NIST NCSTAR 1-1A
Federal Building and Fire Safety Investigation of the World Trade Center Disaster

Design and Construction of Structural Systems

(Appendices A-G)

Appendix A
SUPPORTING DOCUMENTS FOR CHAPTER 2

ALL COLUMNS FABRICATED ON OR BEFORE DECEMBER 16TH SHALL BE COMPLETED WITHIN THE LIMITS OF FOLLOWING TOLARANCES

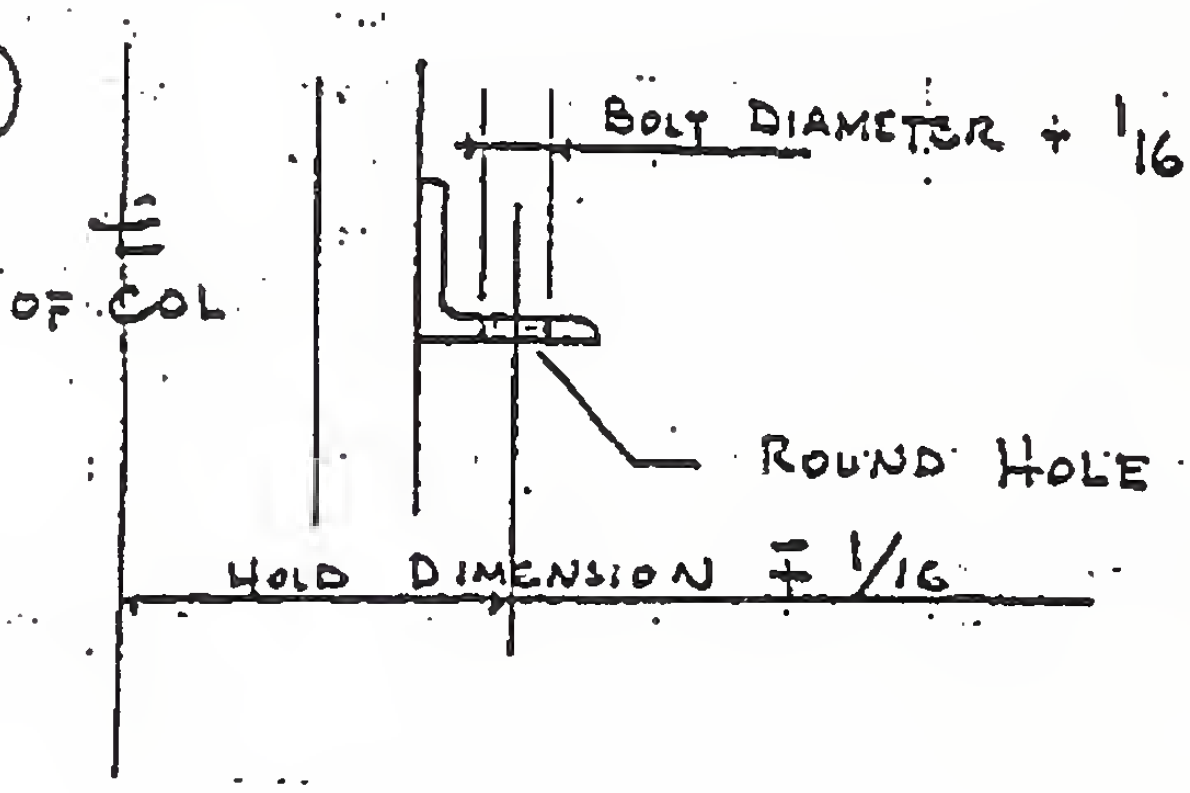
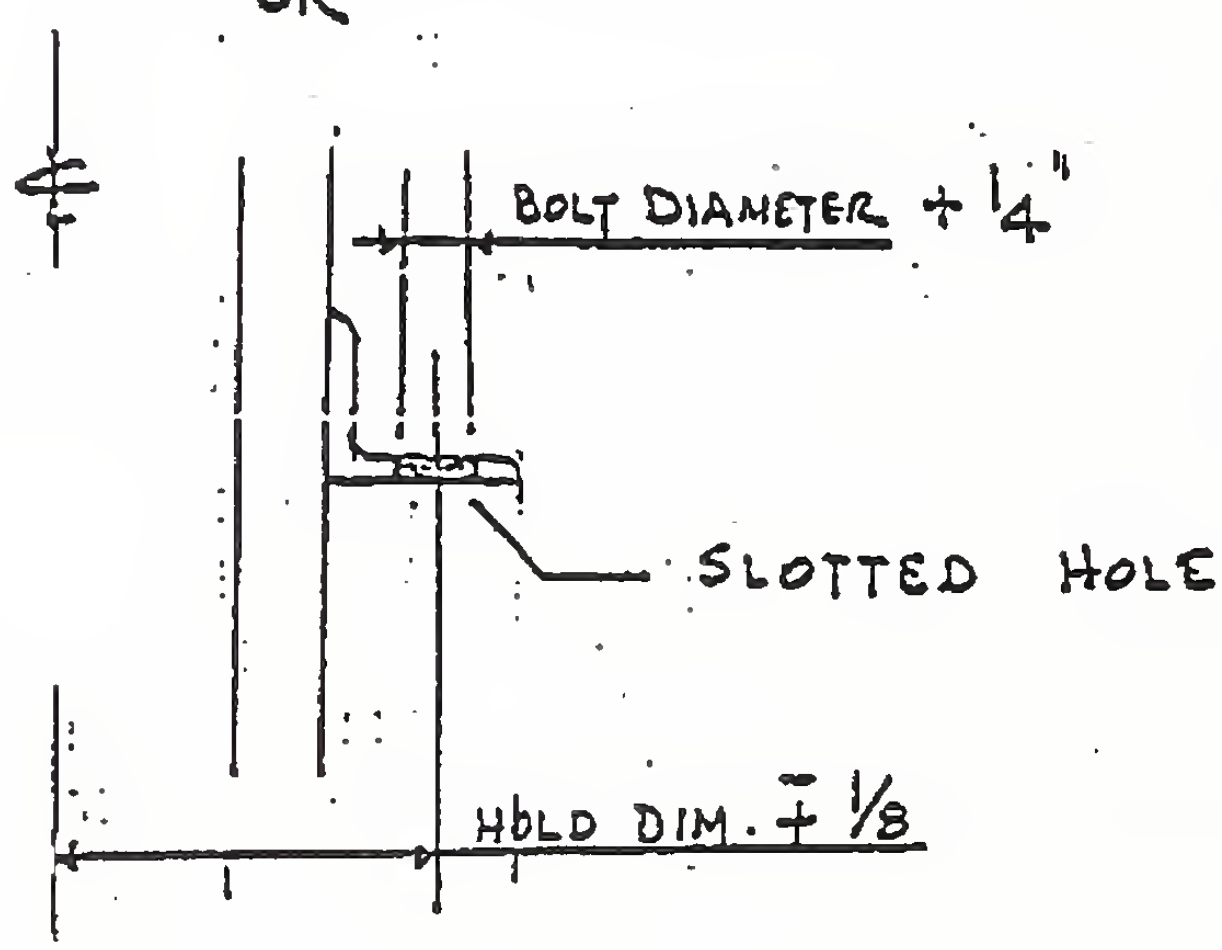
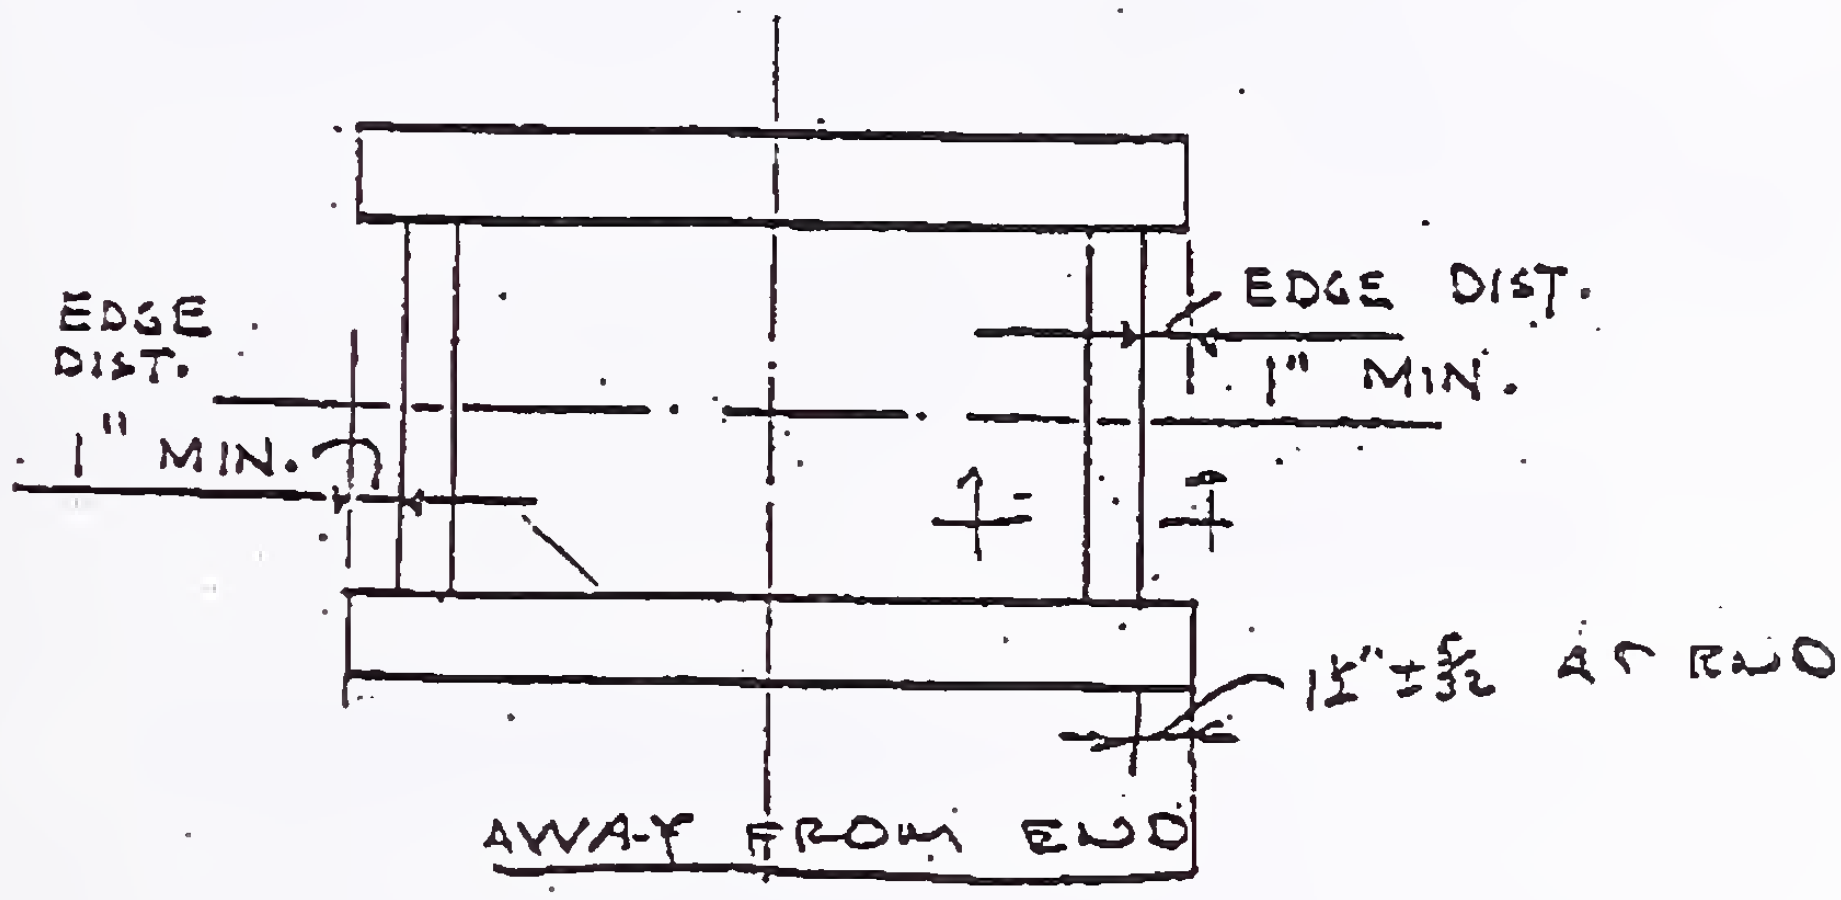
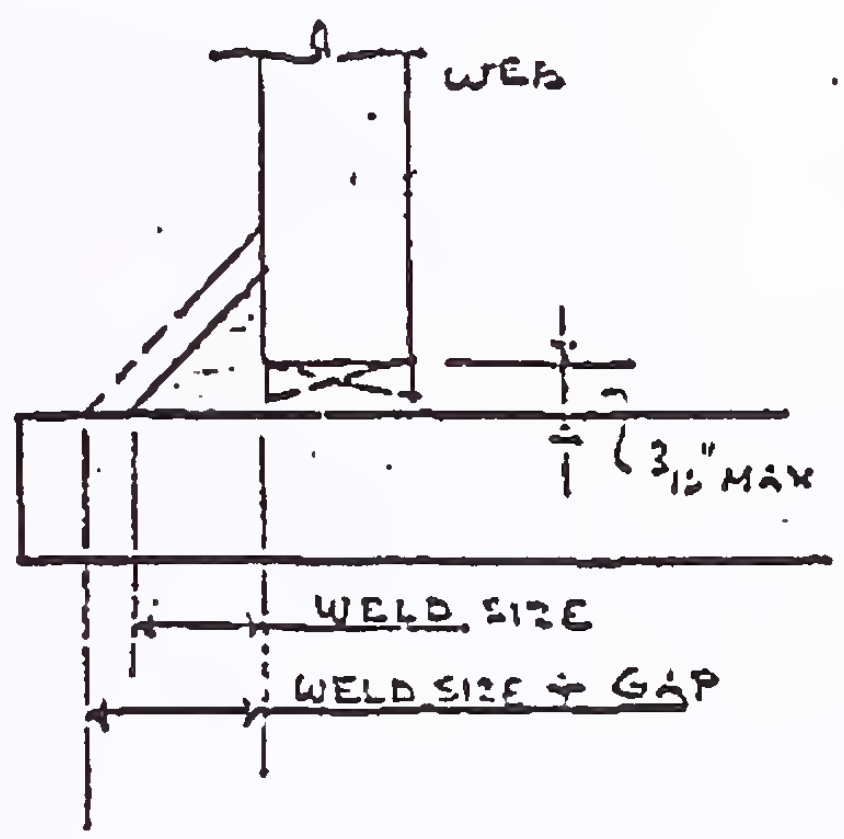
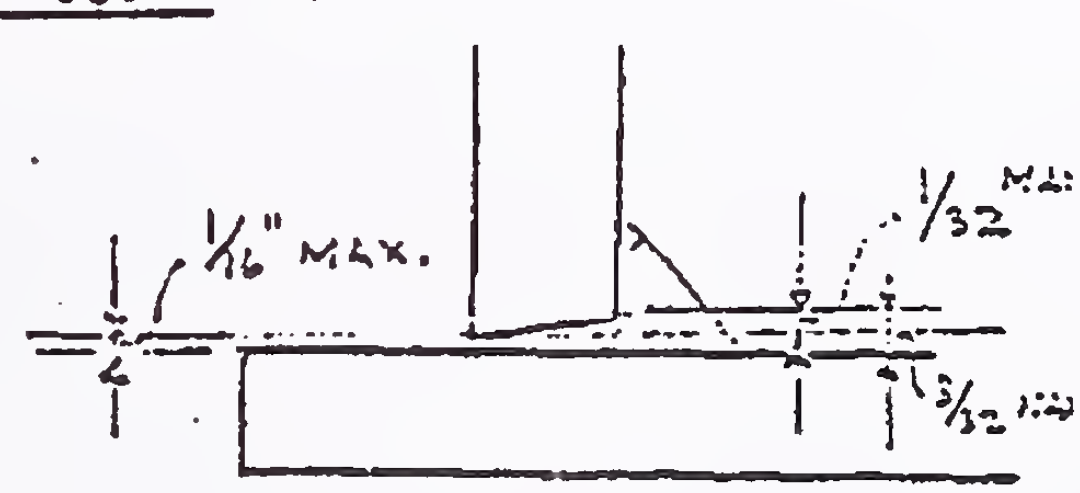
(3) THE GAP AT MIDDLE OF COLUMN SHALL NOT BE MORE THAN 3/16"

WELD SIZE AT GAP SHALL BE INCREASED ACCORDINGLY

GAPS OF 1/16" OR LESS SHALL BE IGNORED

GAPS AT THE END OF COLS

SHALL BE 3/32 MAX. AS SHOWN

IF GAP IS MORE THAN THESE LIMITS PUT 9" LONG FILLET WELD AT INSIDE OF COLUMN STARTING 1" BEYOND MILLED END ACCORDING AISC MIN. WELD SCHEDULE

SKILLING HELLE CHRISTIANSEN ROBERTSON Structural & Civil Engineers	PROJECT World Trade Center	DATE 11-17-69	Sheet No.
	Tolerances	PREPARED BY JTM APPROVED	1

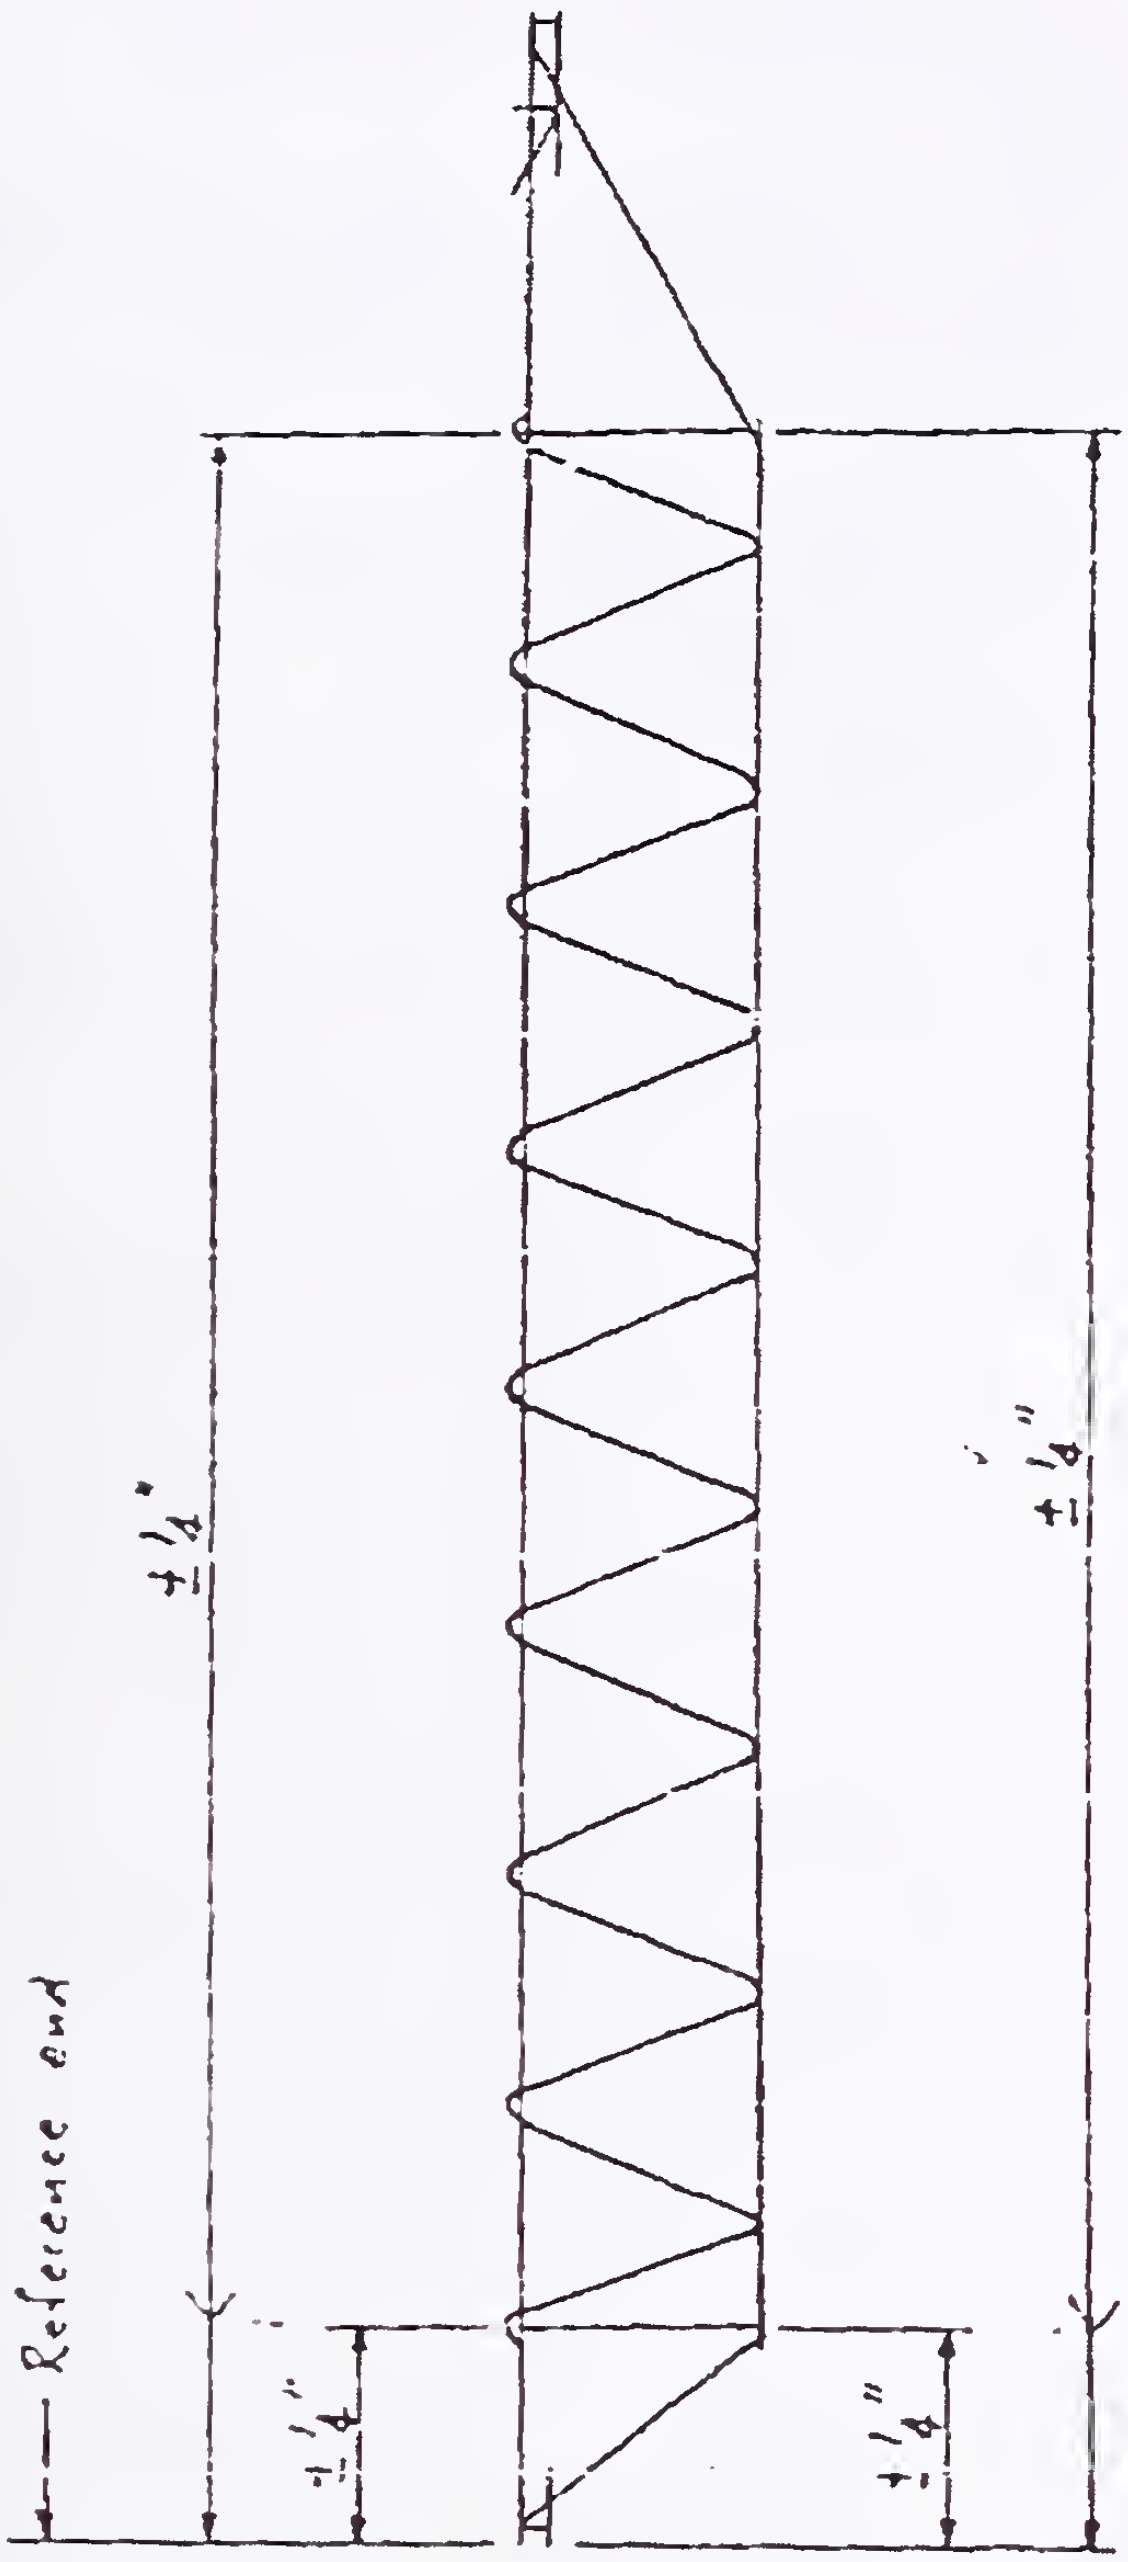
Attached please find SHCR sheet no. 1 showing the required tolerances for the members in question. We approve of Tolerance Schedule 5 on KKE Dwg. T6B (attached to KKE's November 7, 1969 letter) as the maximum allowable tolerances required to fit-up and weld details 13C and 15C as shown on Laclede shop drawings CD209 and CD 205.

Repair details 13C and 15C on KKE Dwgs. T6D and T6C, respectively, are approved, as noted (see attachments). This repair work is to be done at no cost to PNYA in all cases where the tolerances shown on SHCR sheet no. 1 are exceeded.

ACTUAL LENGTH VS. SPECIFIED LENGTH OF TOP DIMENSIONS OF PLATE P91 OF TRUSS CONNECTOR 13-C

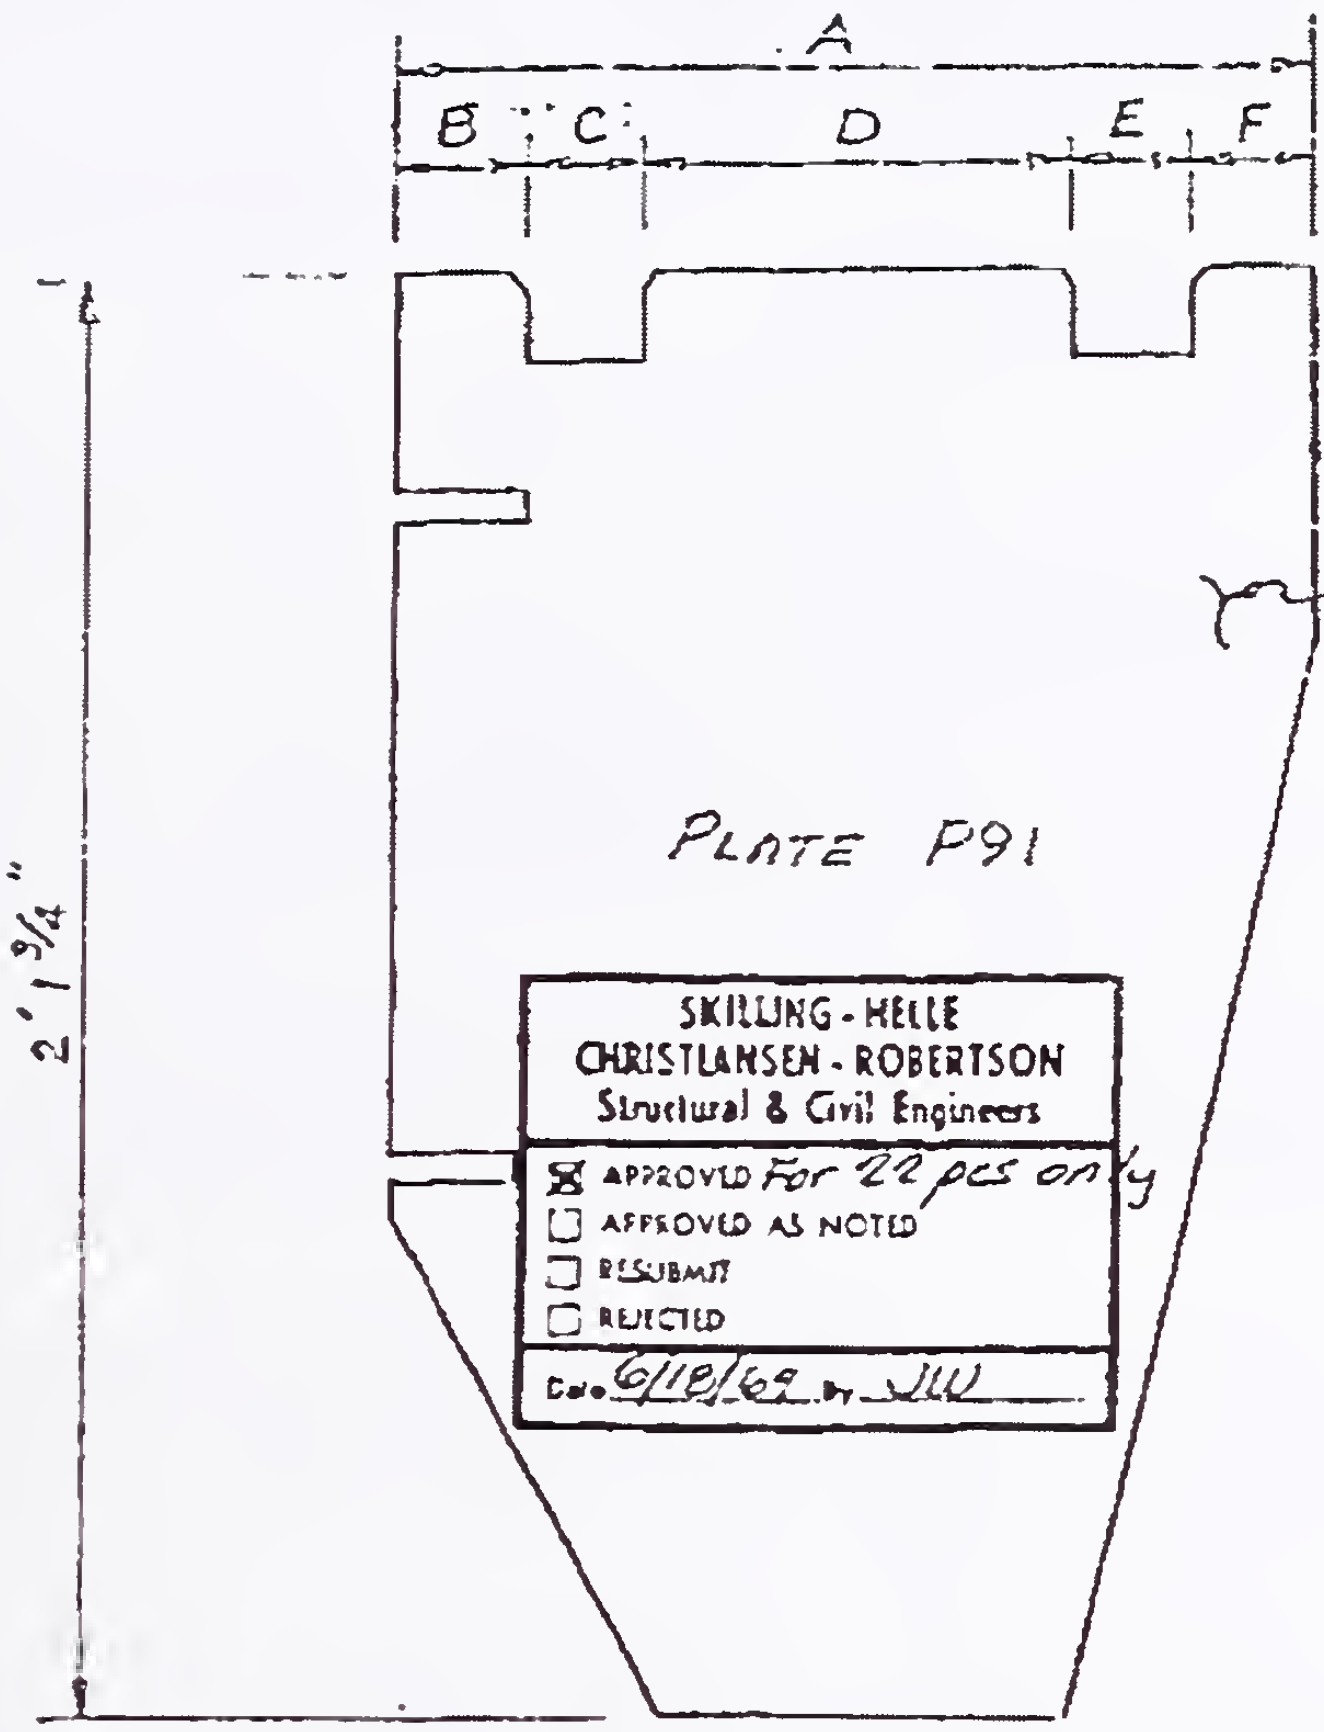
Presently the J. S. Alberici Construction Company which fabricates the truss connectors we supply for the World Trade Center has 22 pieces of our material which is 1/4" under the required width. These pieces are 12-3/4" x .500" x 2'1-3/4"; they should be 13" x .500" x 2'1-3/4". Alberici has already cut this material and notched it as shown in the accompanying drawing (JS-13-91). These pieces which are to be used for truss connector mark 13-C have dimensions which correspond to those shown on Laclede Drawing ST-274 dated 6-13-68 with the exception of dimensions "A" and "F" which are 1/4" shorter than the corresponding dimensions shown in ST-274.

The only problem involved with using this short material would be that the length of weld between truss connector 13-C and the horizontal bridging angle at their connection point (see attached SCHR drawing 7-AB4-13) would be reduced by 1/4" top and bottom. As far as fitting the truss connector there will be no problem since all critical dimensions have been held.
